**Application For Reissue of
U.S. Patent No. 6,000,374**

For: MULTI-CYCLE, ENGINE BRAKING WITH POSITIVE POWER VALVE
ACTUATION CONTROL SYSTEM AND PROCESS FOR USING THE
SAME

Preliminary Amendment in Reissue Application

Request for Approval of Drawing Changes

Fig. 21
NEW

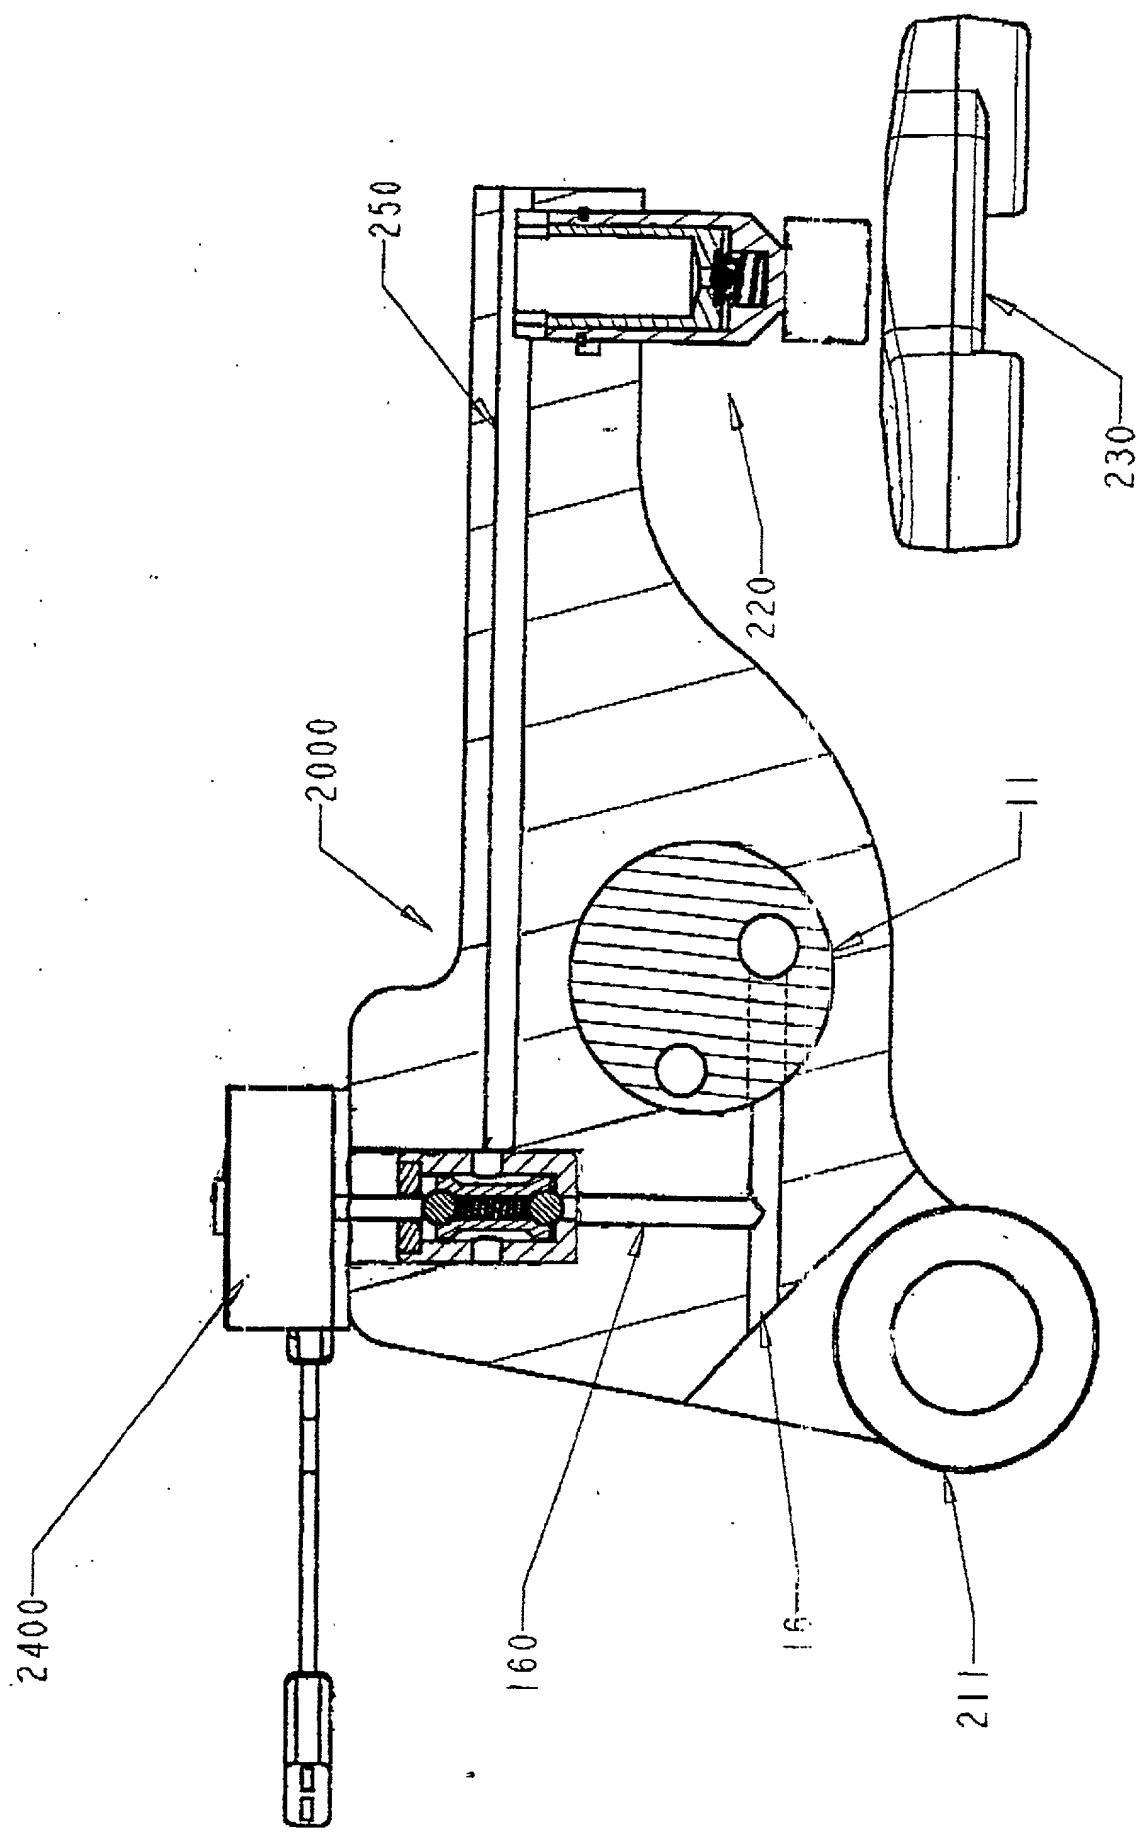
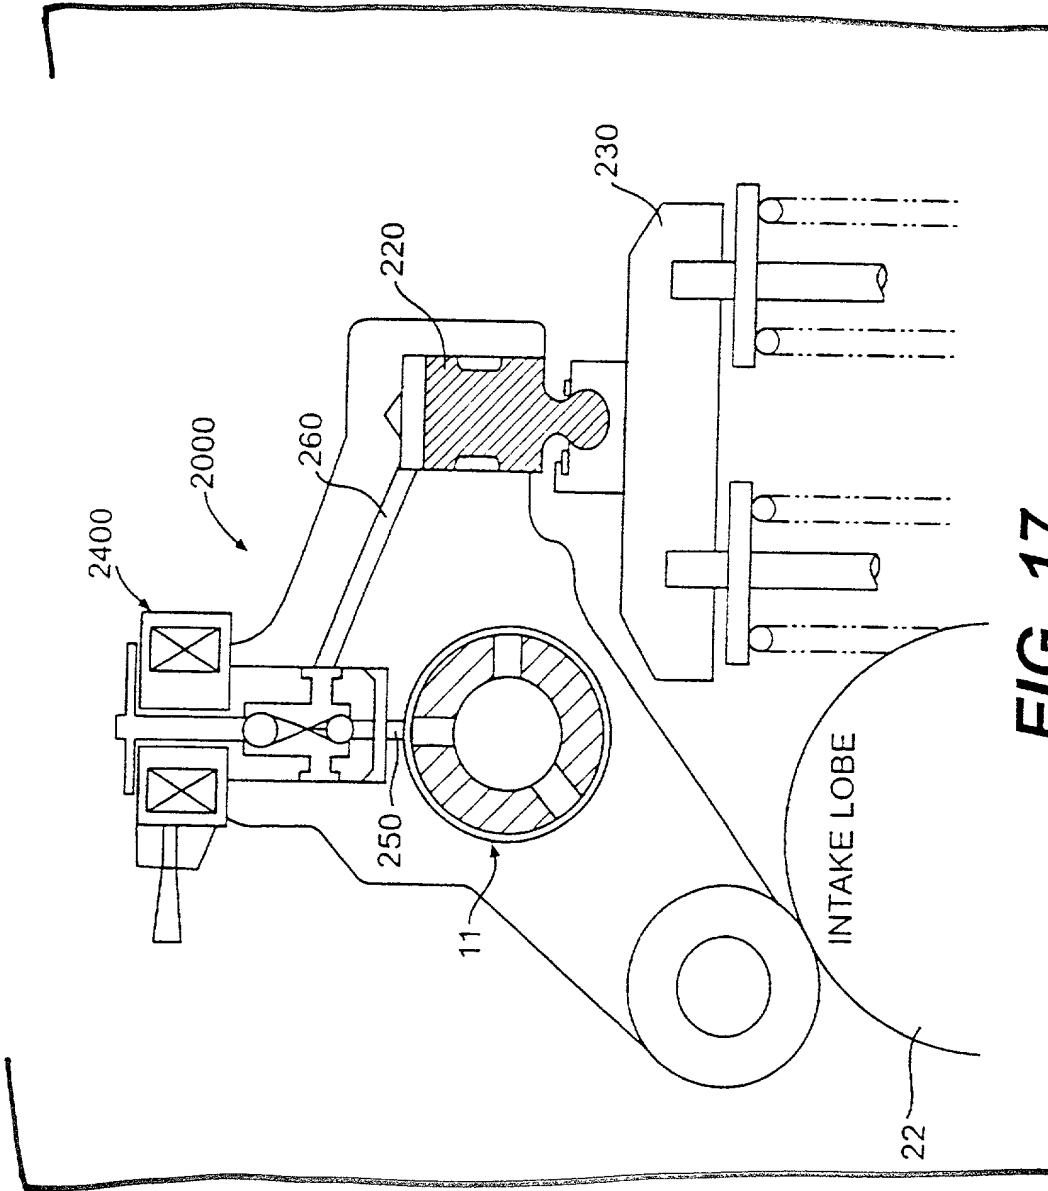
Fig. 21 is a side view of an intake rocker arm according to an alternate embodiment of the present invention.

Fig. [17] **21** is an alternative embodiment for the means for effecting intake valve operation. The intake rocker arm **2000** is rotatably mounted on the common rocker shaft **11**. A second end of the intake rocker arm **2000** has a lash adjuster **220**. The intake rocker arm **2000** also includes a combination control valve/solenoid valve 2400. The [solenoid] valve **2400** is in communication with a fluid passageway **250** that extends through the exhaust rocker arm **2000** to the lash adjuster **220**. The solenoid valve **2400** has the same construction as the [solenoid] valve **1400** described above in connection with the exhaust rocker arm **1000**.

Pursuant to 37 CFR §§ 1.121 and 1.173, Applicants respectfully request approval of the changes indicated in red on the attached sheets for the above-referenced reissue application. The changes are necessary to correct errors inadvertently incorporated into the above-referenced original patent. In particular, Figs. 3, 4, 6, 7, 8, 11, 12, 14, and 18 are amended, Figs. 5, 9, 10, 13, 15, 16, and 17 are canceled, and Figs. 19-21 are added. Figure 19 corrects errors in, and in effect replaces, canceled Fig. 9. Figure 20 corrects errors in, and in effect replaces, canceled Fig. 16. Figure 21 corrects errors in, and in effect replaces, canceled Fig. 17.
